ADDENDUM NO. 1

ISSUE DATE: April 2, 2020

DAWSON FOREST WRF SLUDGE DEWATERING UPGRADES

ETOWAH WATER & SEWER AUTHORITY
DAWSONVILLE, GEORGIA

SCALE: As indicated
 NOTE: DRAWING SCALE IS BASED ON 24X36 SHEETS.
 DATE: 2/26/2020
 DRAWING: S.09
 SHEET: 29 OF 44

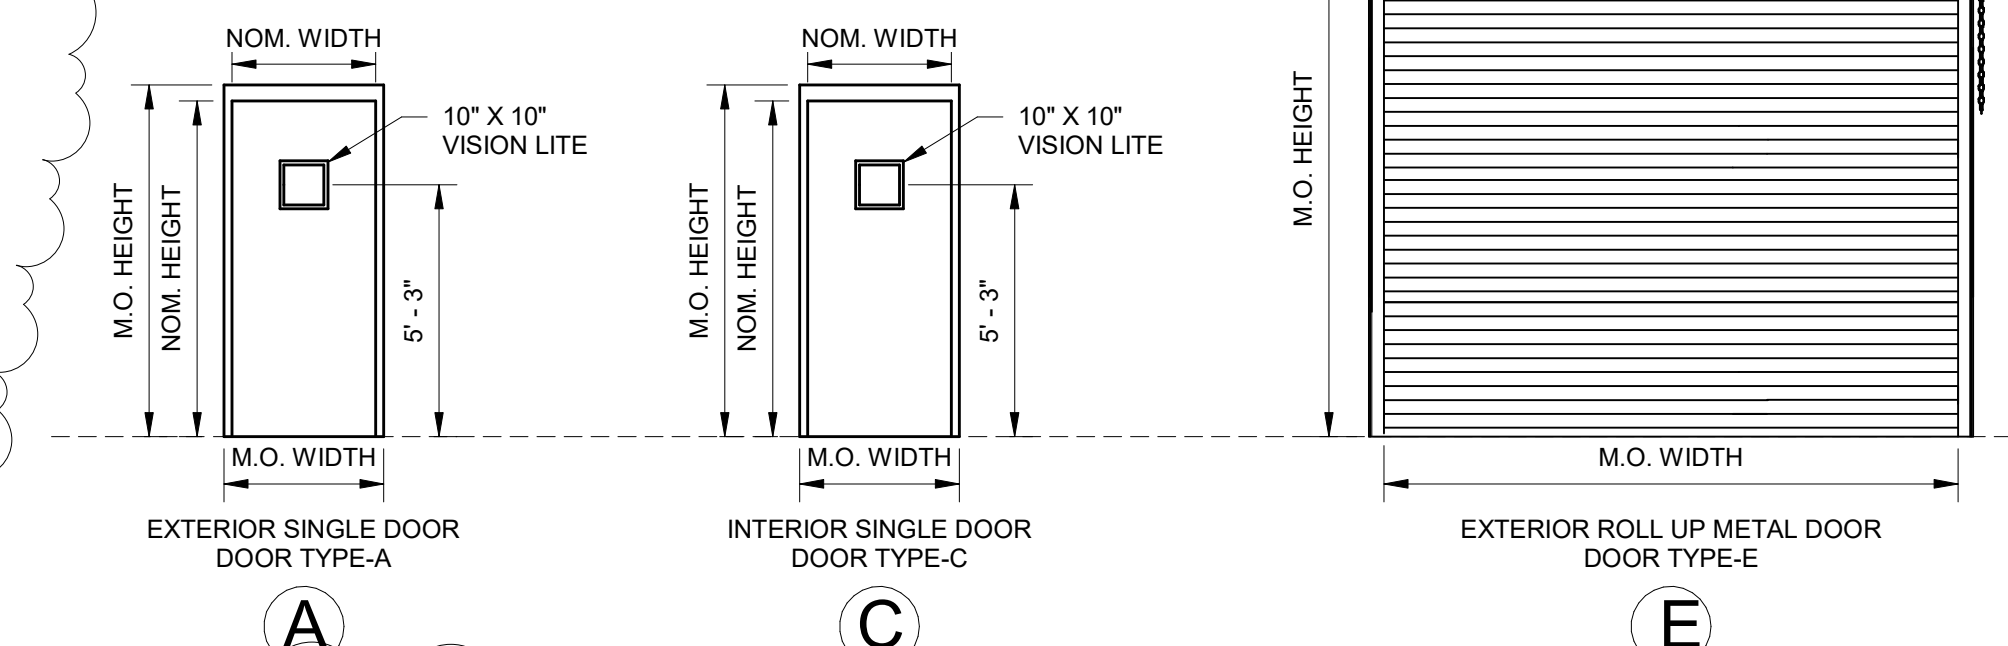
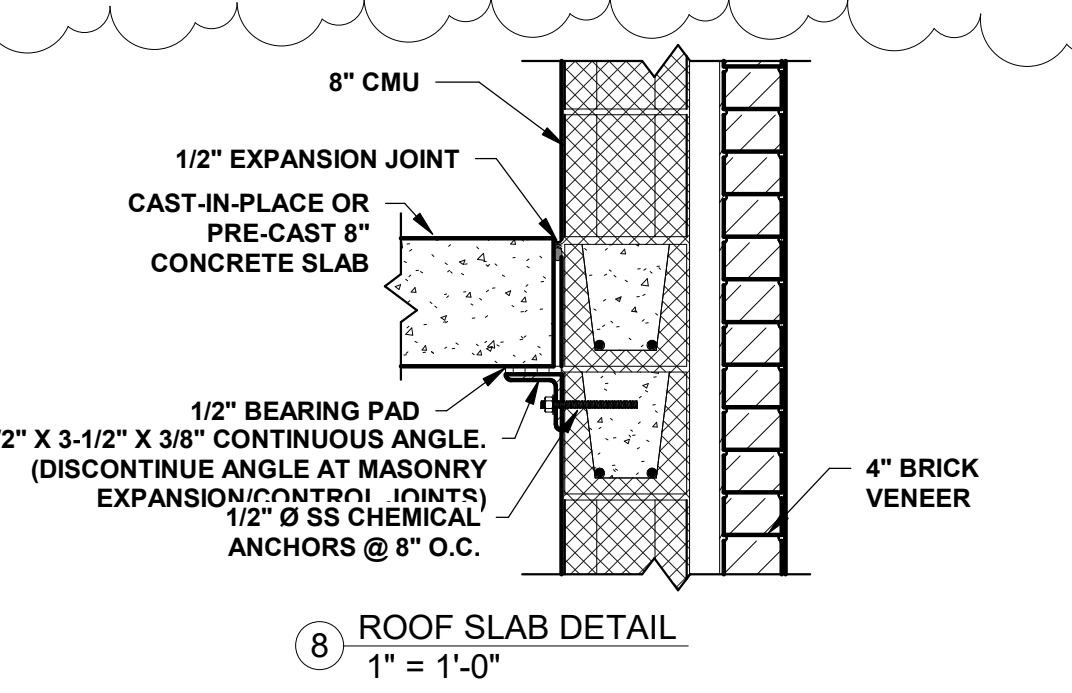
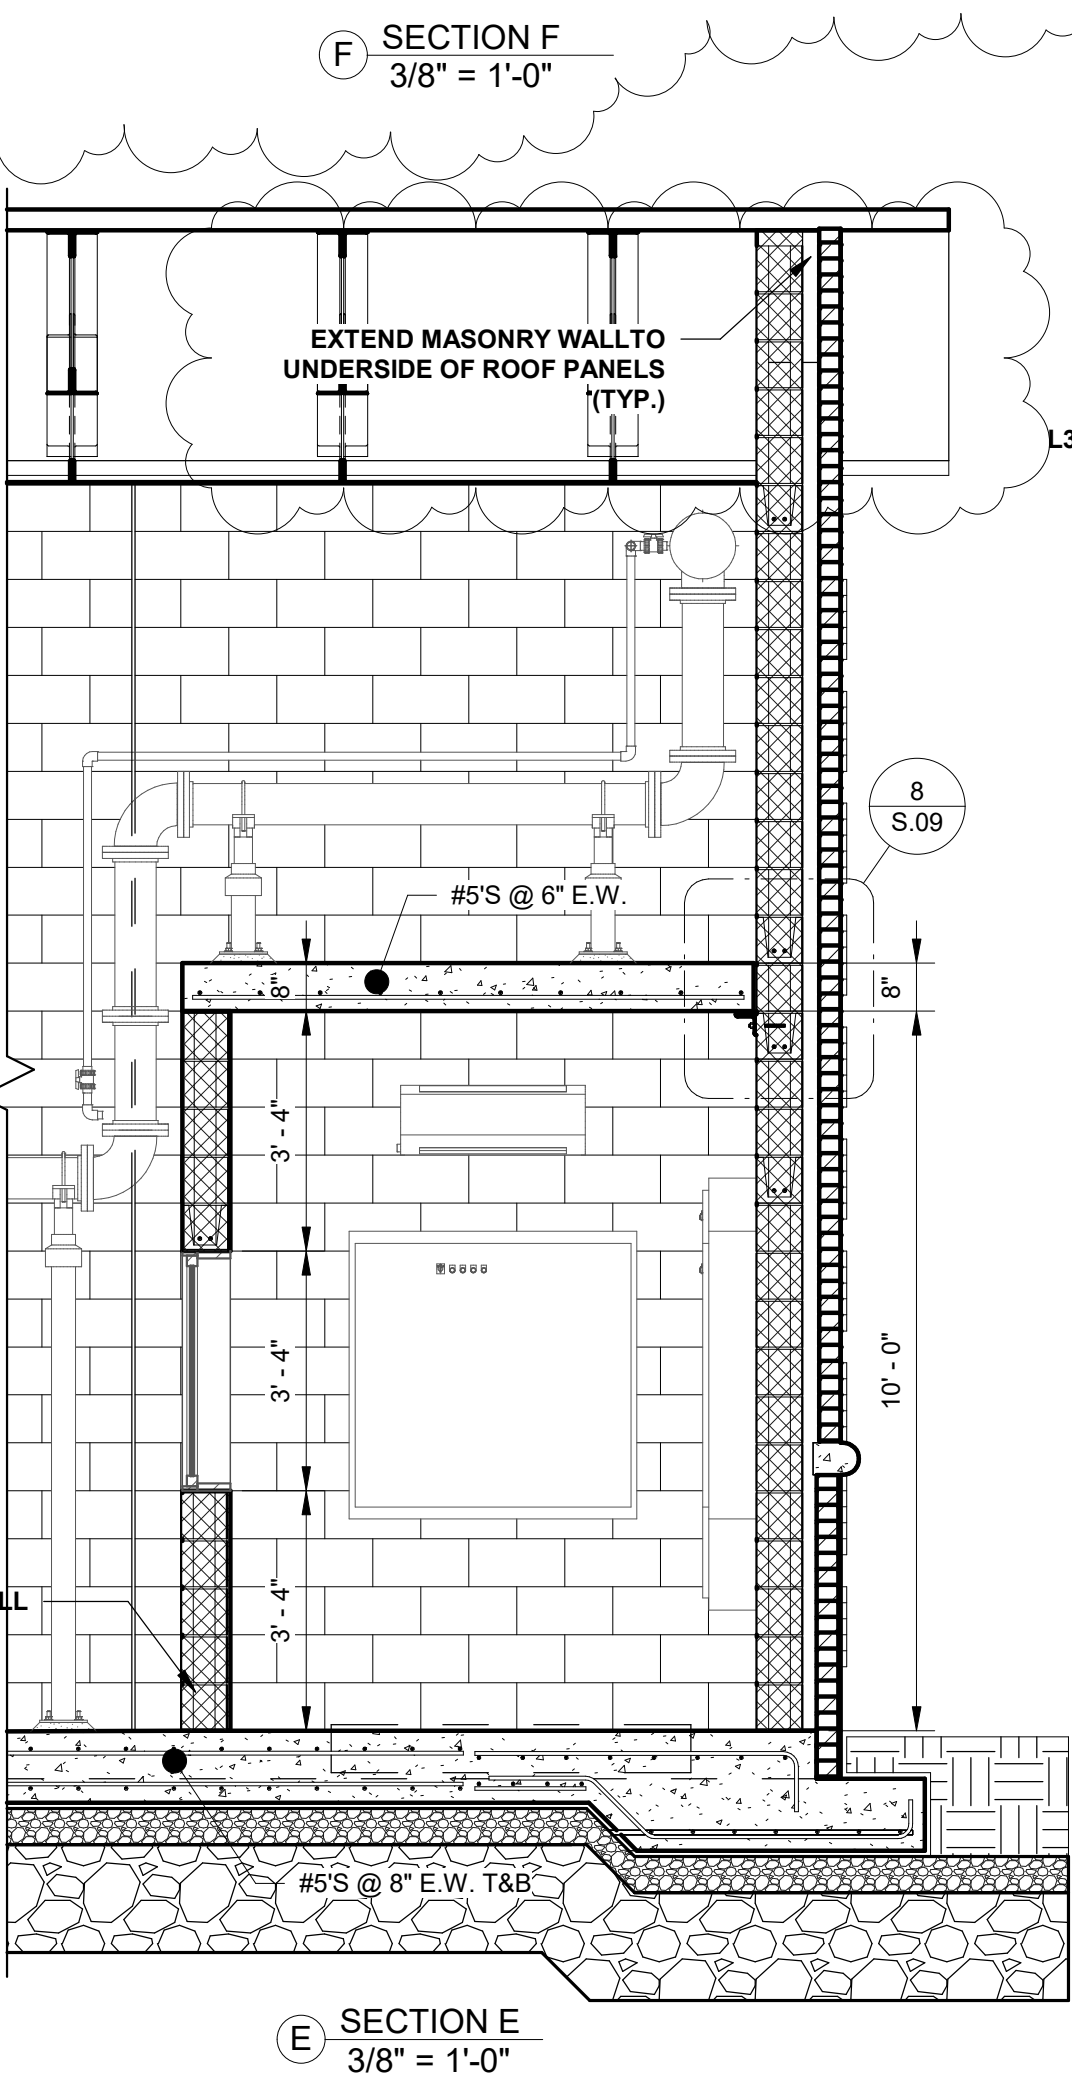
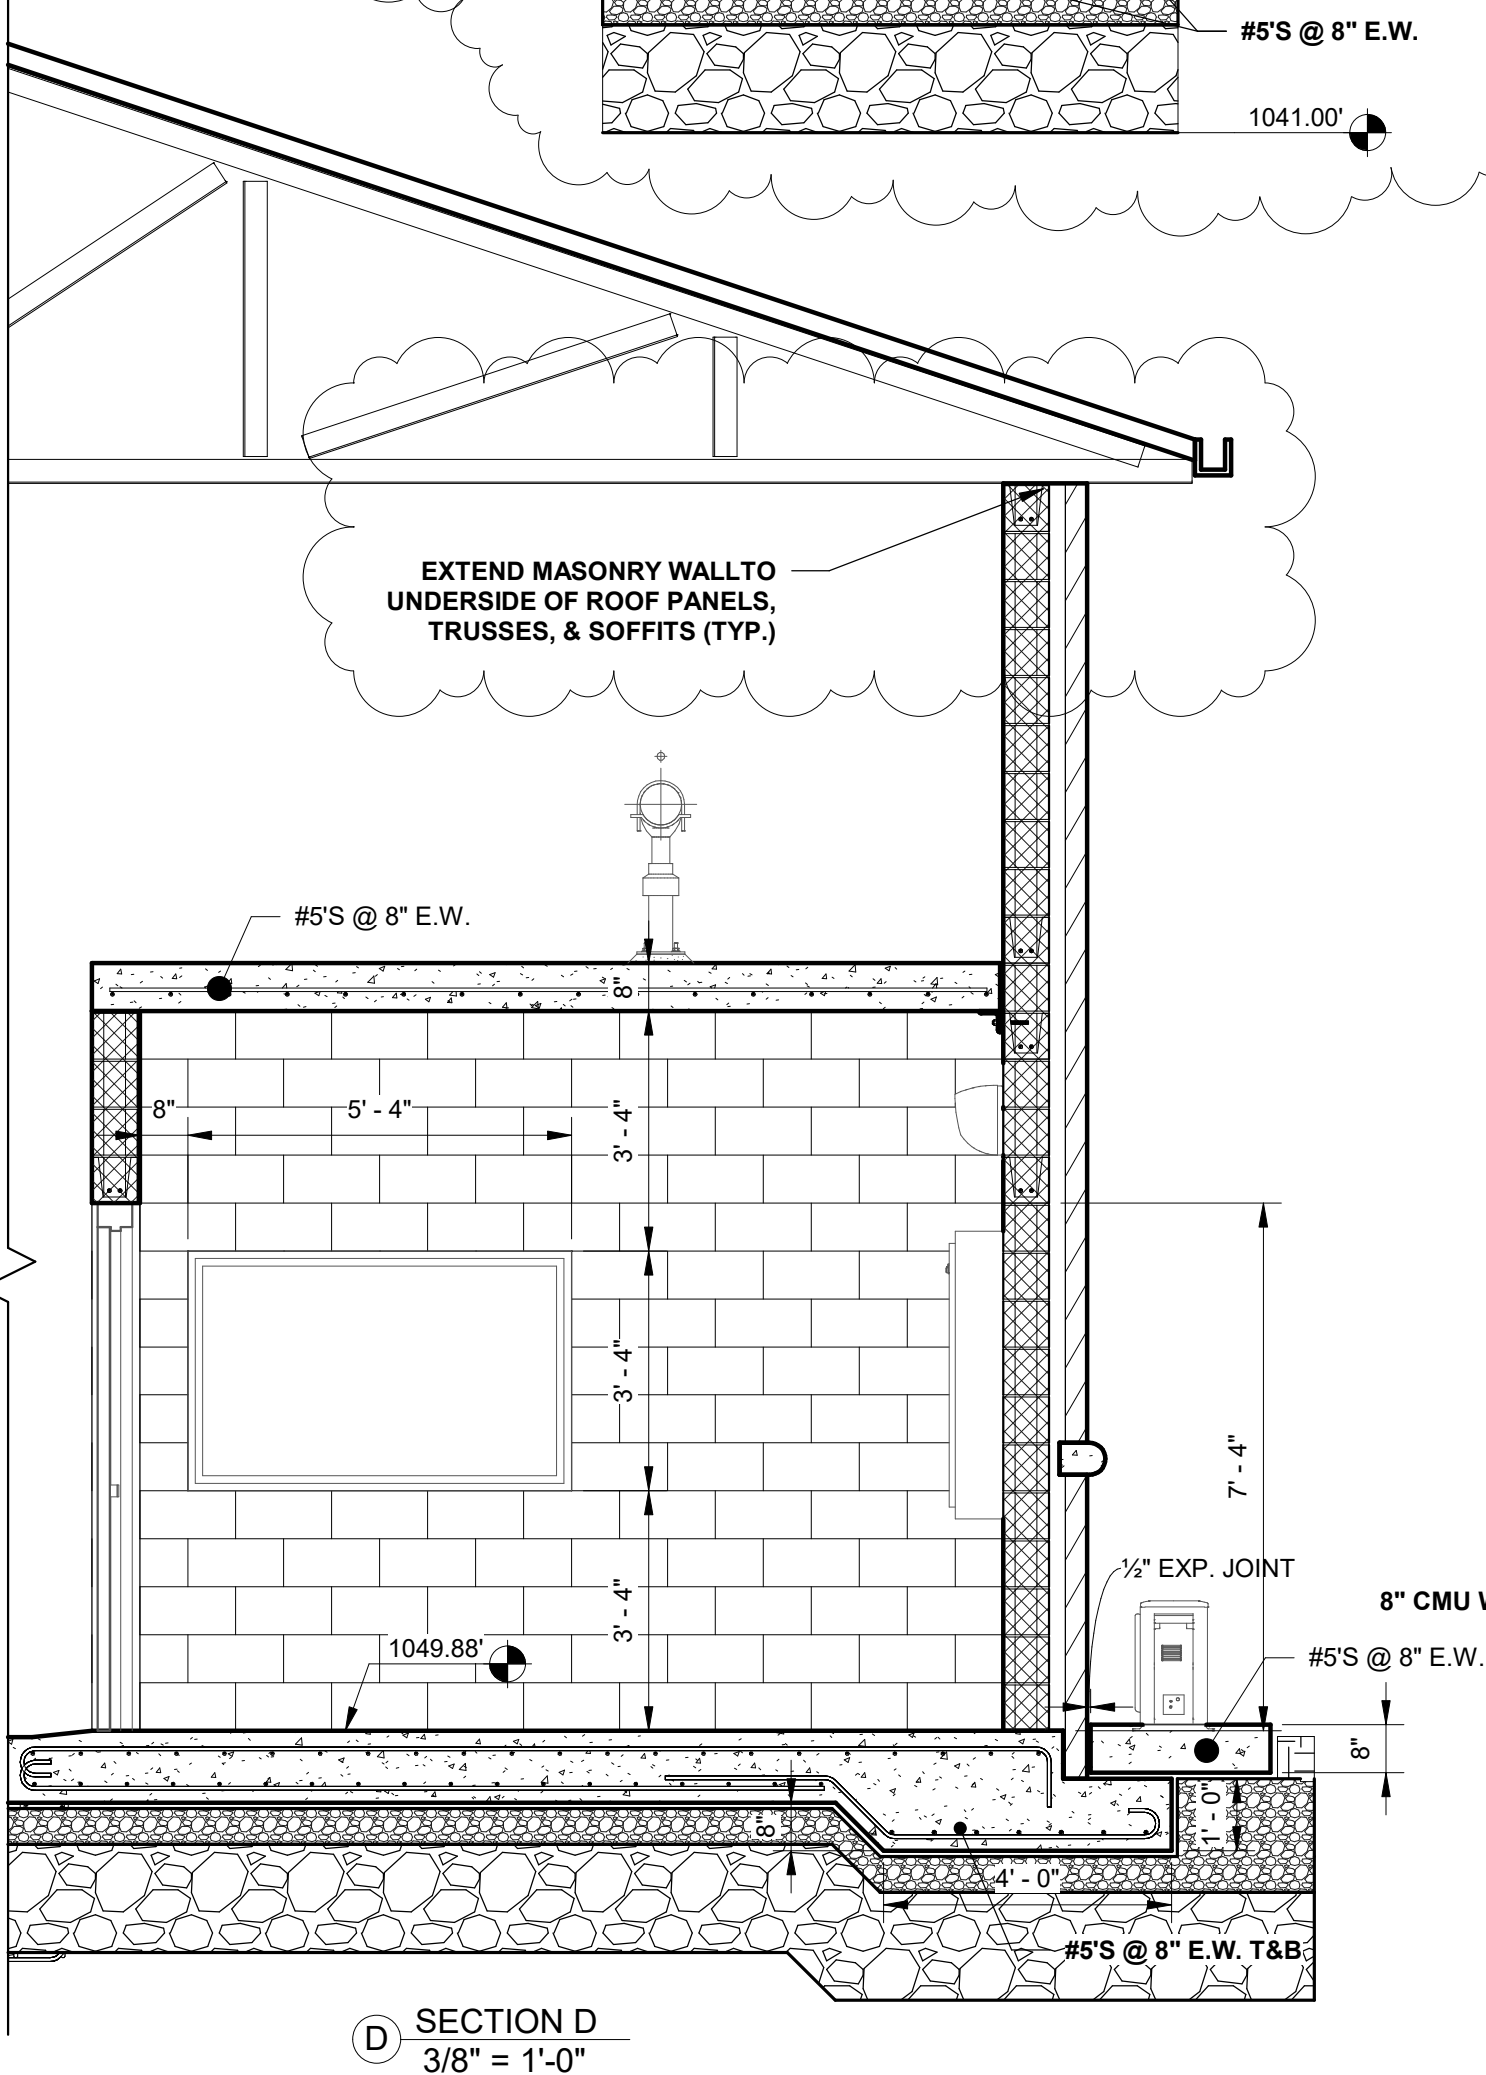
26	Plan sheet S.09, section F – please provide dimensions for the slab thickness in the dumpster area. Please provide elevations for the sloping dumpster slab (what is the elevation of the slab all the way to the right)?	The slab dimension is 8-inches. This will be clarified in Addendum No.1.
27	How thick is the sidewalk around the dumpster pad?	The sidewalk around the dumpster area will be a standard 4-inch thick sidewalk. This will be clarified in Addendum No.1.
28	Specification section 01 77 00.B states the warranty period is one year. Paragraph C states the warranty period is five years. Please clarify.	Paragraph C refers to "latent defects" that may be found after the 1-year warranty period referenced in paragraph B.
29	The bid form lists a cash allowance for soils and concrete testing in the amount of \$15,000. Specification section 03 30 00.3.9.A states "the contractor shall arrange and pay for all concrete testing services on the referenced project." Please clarify how onsite concrete testing will be paid for.	Per paragraph 3.9, A. of Section 03 30 00, the Contractor shall arrange and pay for all concrete testing services. However, the Owner will reimburse the Contractor for all services and testing invoices issued by Southern Geotechnical Consultants using the \$15,000.00 cash allowance in the Bid Form. Any other costs incurred by the Contractor associated with concrete testing shall be included in their lump sum bid.

E.03-1

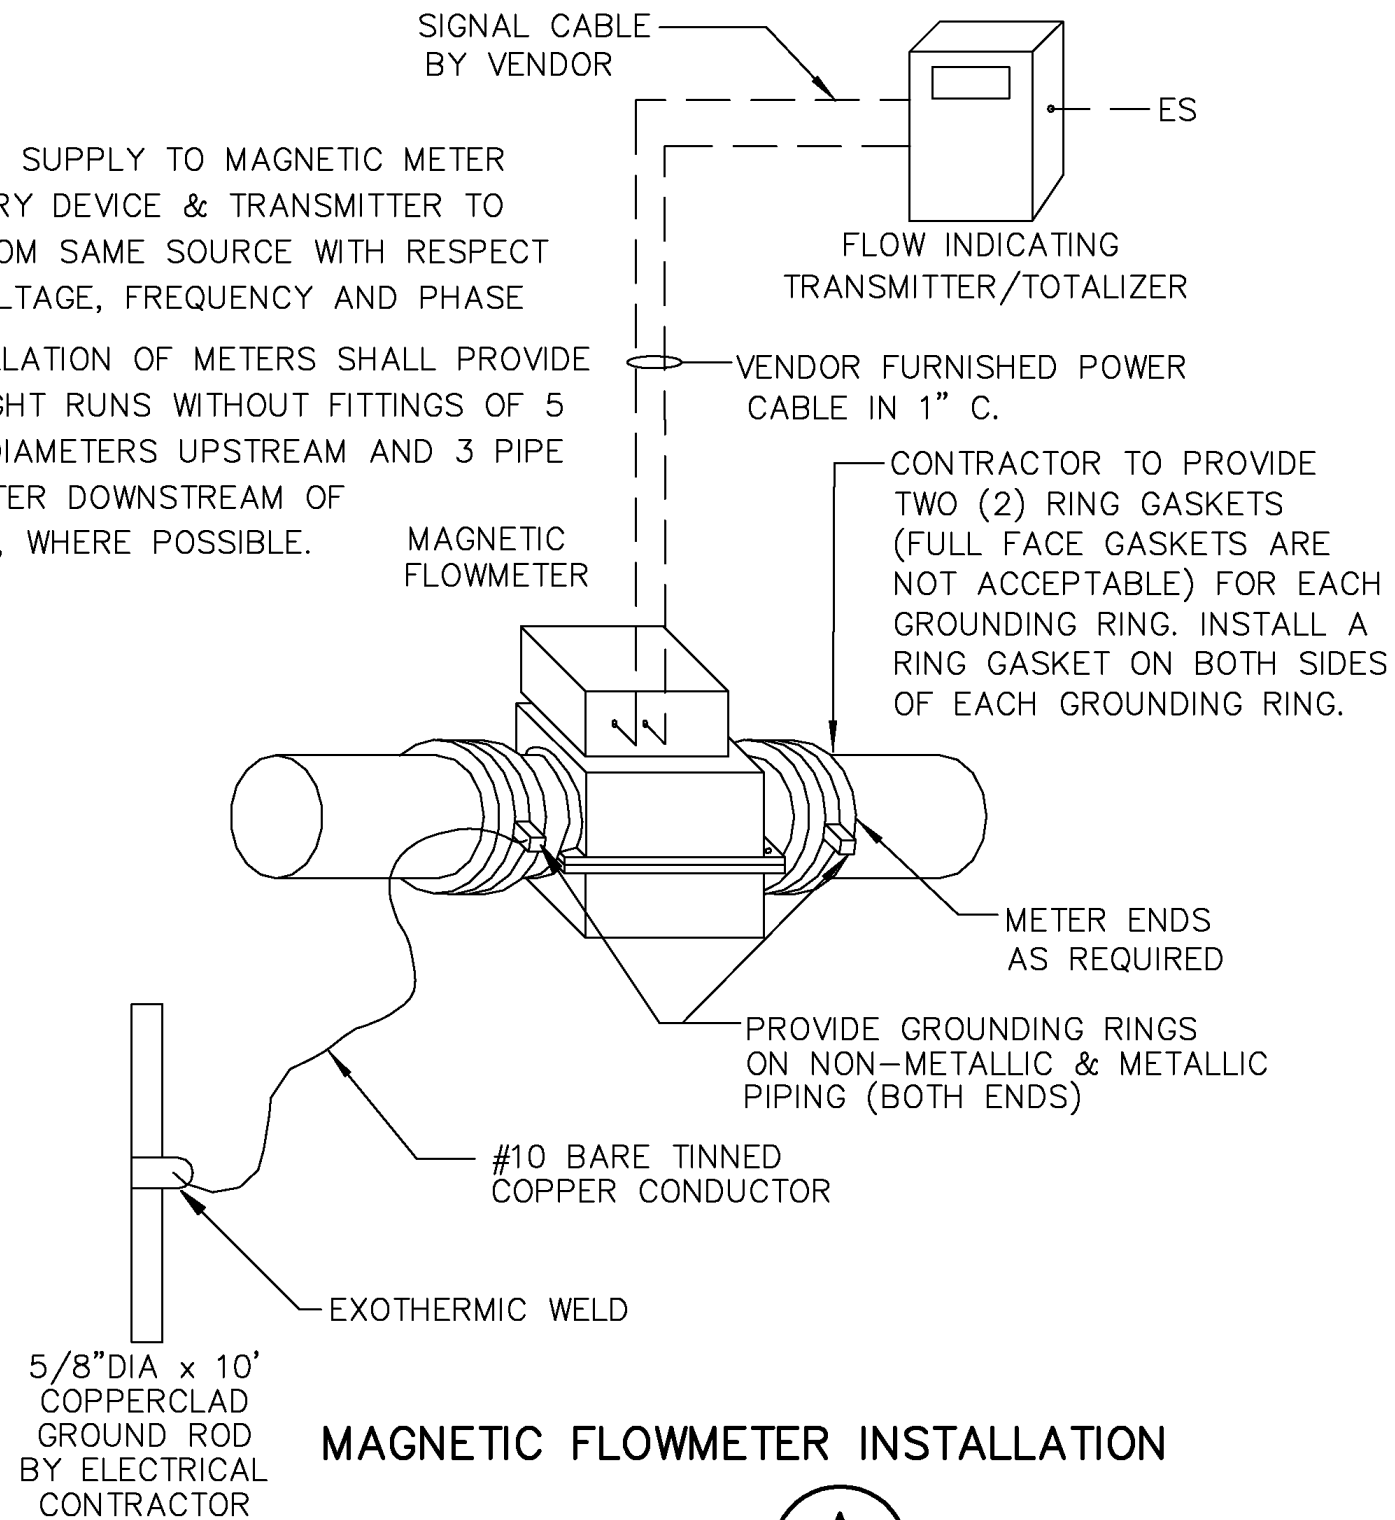
- d. **ADD the “MAGNETIC FLOWMETER INSTALLATION DETAIL” to Drawing E.03-1 as shown in the attached Sketch E.03-1.**

1. POWER SUPPLY TO MAGNETIC METER PRIMARY DEVICE & TRANSMITTER TO BE FROM SAME SOURCE WITH RESPECT TO VOLTAGE, FREQUENCY AND PHASE
2. INSTALLATION OF METERS SHALL PROVIDE STRAIGHT RUNS WITHOUT FITTINGS OF 5 PIPE DIAMETERS UPSTREAM AND 3 PIPE DIAMETER DOWNSTREAM OF METER, WHERE POSSIBLE.

MAGNETIC FLOWMETER INSTALLATION
